CERTIFICATE OF APPROPRIATENESS

This letter provides you with confirmation that the proposed changes to your designated Fort Collins landmark property, the Maneval/Mason/Sauer Property at 100 First St., have been approved by the City's Historic Preservation Division because the proposed work meets the criteria and standards in Chapter 14, [Article IV](#) of the Fort Collins Municipal Code.

- 1) Floor joist system conforming with recommendations of structural engineer to address over span in floor joists in kitchen and areas of makeshift supports (see attachments)

RE: Comments concerning improved support of kitchen floor system, 100 1st Street, Fort Collins, CO 80524. REI Project 21-019.

Floor Support Plan Single Span Middle Beam

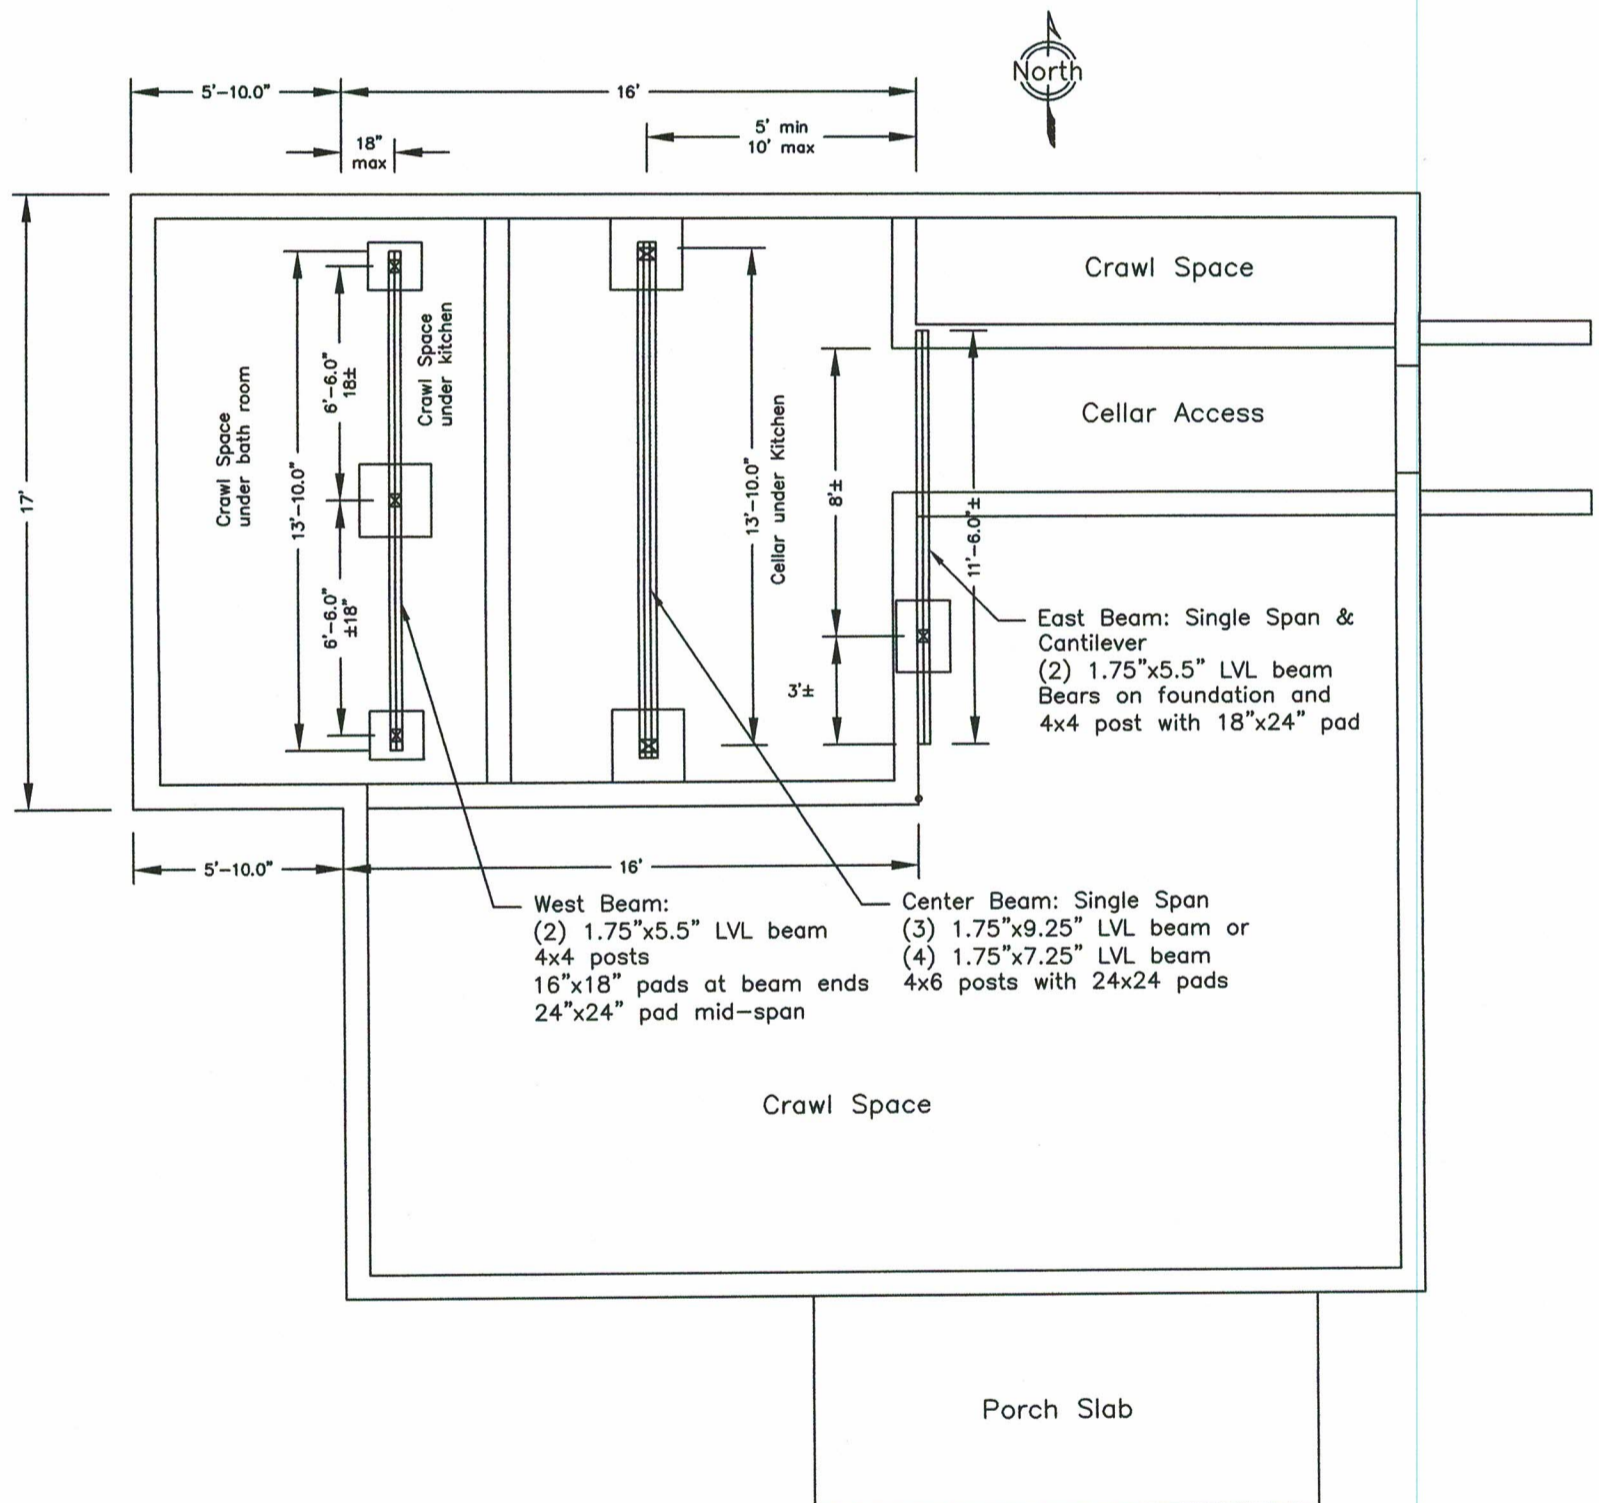
The concern expressed by the owner was the support of the kitchen floor. The floor joists were 2x8 rough sawn joists 24" c/c +/- spanning 16'. In 1904, that floor span would have been a long one, but not necessarily out of character for the home. I did look for evidence of a mid-span support beam, but there were no indication of such a beam. The floor has been supported by a number of added posts and spreaders indicating the floor may have had noticeable deflection. For current day loadings, considering a 40 psf live load and 12 psf material weight, the floor joists would be significantly over span resulting in high bending stresses and a very bouncy floor. To complicate matters, the walls either side of the kitchen support the roof over the kitchen. The west wall also supports the roof over the 6' wide shed roof over the bathroom and west side entry. On site, I initially proposed adding support under the east and west walls of the kitchen. I now also suggest adding a beam support mid-span of the joists.

Our recommendation would be for adding three beams as follows:

Middle Beam - If 2-span with 3 posts, a built-up (3) 1.75"x5.5" LVL approximately 15' long supporting all floor joists except the rim joists for the original floor system. The spans can be 6'-4" c/c if equally spaced, but the center support may be adjusted 24" c/c either way if needed. For 2-span, the two end posts can bear on 16"x18" (2ft²) bearing pads and the center post should bear on a 24"x24" (4ft²) bearing pad. If the 2-span LVL needs to be sliced locate splices at 1/3 span locations, with only one layer spliced at any 1/3 span location. If single span with only (2) posts, a built-up beam could be either (2) 1.75"x11.25" LVL, (3) 1.75"x9.25" LVL or (4) 1.75"x7.25" LVL. The LVL layers of the beam should be mechanically laminated by 2 rows 10d (0.128"x3") nails (min) 12" c/c between each LVL layer. Single span LVL should not be spliced. The posts can be 4x4 HF or DF #2 (min). Use post to beam hardware such as the Simpson AC post caps. We recommend ABS plastic or treated wood bearing pads. The pad should bear on a leveled, compacted surface. Once the beam is installed, toe-nail each floor joists to the beam by (3) 8d common nails and add blocking between joists, over beam, alternate openings.

West Beam – Built-up (2) 1.75"x5.5" LVL if LVL material continuous or (3) 1.75"x5.5" LVL if LVL spliced, approximately 14'+/- long supporting all floor joists except the rim joists for the original floor system. The beam should be located within 18" of the west kitchen floor rim joists and would be installed below the floor joists. The LVL layers of the beam should be mechanically laminated by 2 rows 10d (0.128"x3") nails (min) 12" c/c between each LVL. It is better not to splice the beam, but if the LVL needs to be sliced, locate splices at 1/4 span locations, with only one layer spliced at any 1/4 span location from any post. The spans can be 6'-4" c/c if equally spaced, but the center support may be adjusted 24" c/c either way if needed. The posts should be 4x4 HF or DF #2 (min) posts and connect each beam to post by post to beam hardware such as Simpson AC post cap. The end posts should be reasonably close to the beam ends but need to be centered on bearing pads as close to the cellar walls or crawl space walls as possible. The two end posts can bear on 16"x18" (2ft²) bearing pads, the center post should bear on a 24"x24" (4ft²) bearing pad. We recommend ABS plastic or treated wood bearing pads. The pad should bear on a leveled, compacted surface. Once the beam is installed, toenail each floor joists to the beam by (3) 8d common nails and add blocking between joists, over beam, alternate openings.

East Beam – Built-up (2) 1.75"x7.25" LVL (min) approximately 11' +/- long attached to the existing floor 2x8 rim-board(s). The LVL layers of the beam should be mechanically laminated by 2 rows Ledger LOKs or Timber LOKs 8" c/c max through all the LVL and existing rim board material. If LVL needs to be spliced contact our office. The added beam should be supported from the existing concrete wall and adjacent soil at 8' +/- from the north support. The beam should extend 3.5' +/- south of the post. The post should be 4x4 HF or DF #2 (min) posts and connect to the post by Simpson AC type hardware. The posts should be just east of the partial wall forming the edge of the cellar. The posts can bear on an 18"x24" (3 ft³), bearing pad and can bear partially on top of the concrete wall with the soil next to the wall filled and compacted to the same height as the wall. We recommend ABS plastic or treated wood bearing pads.
